# SERVICE SLANTS

ISSUED BY WURLITZER SERVICE DEPT., NORTH TONAWANDA, N. Y.

SUBJECT: Kit 147 Modification for use with Phonograph Models 1800, 1700F, 1700, 1600AF, 1650AF, 1600A, 1650A and 1500AF.

FIGURE 1

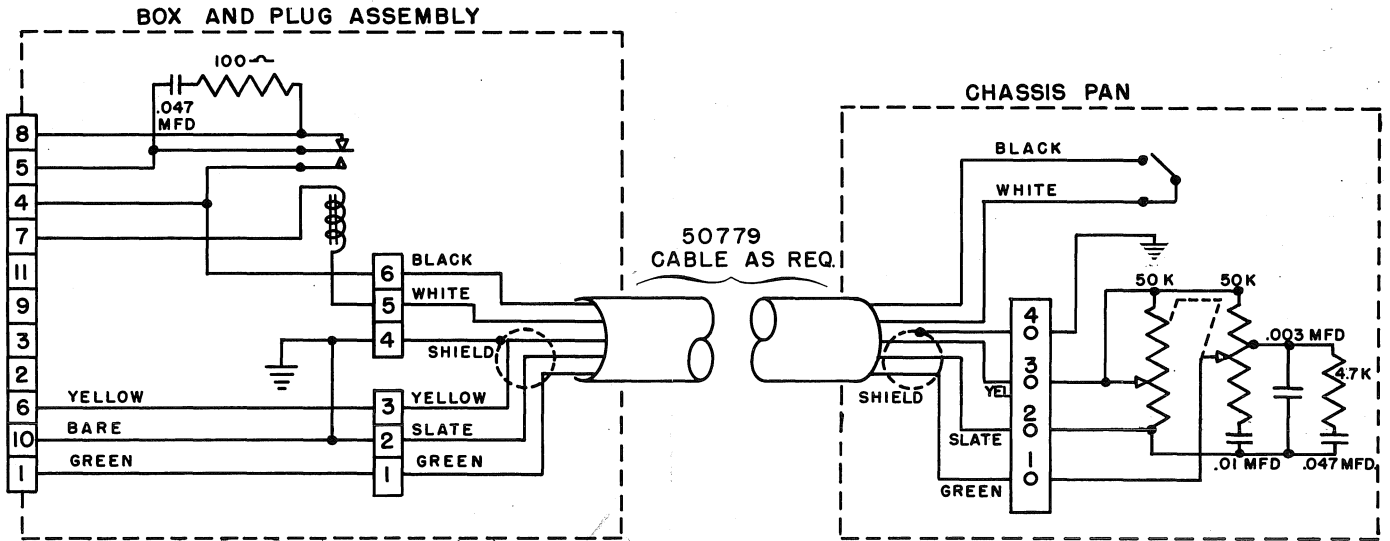
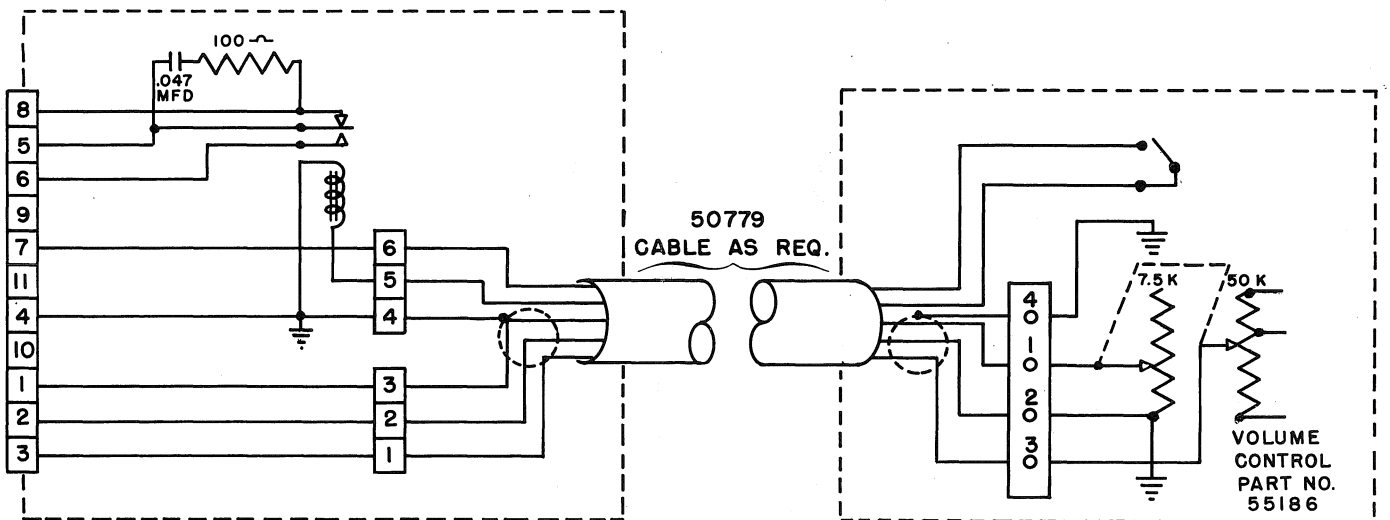
To make the necessary changes in the wiring of the "Relay, Box and Plug Assembly" remove the wires from all except pins 5 and 8 of the 11 prong plug. Take note or mark the wires from pins 1, 4, 6, 7, and 10. Install and solder these wires in pins 3, 6, 1, 4, and 2 respectively.

Figure 1 represents the wiring of Kit 147 before modification. Figure 2 represents wiring of the modified Kit 147, without the tone compensation installed. Check all connections with Fig. 2 and one of the figures on sheet 3 of 3.
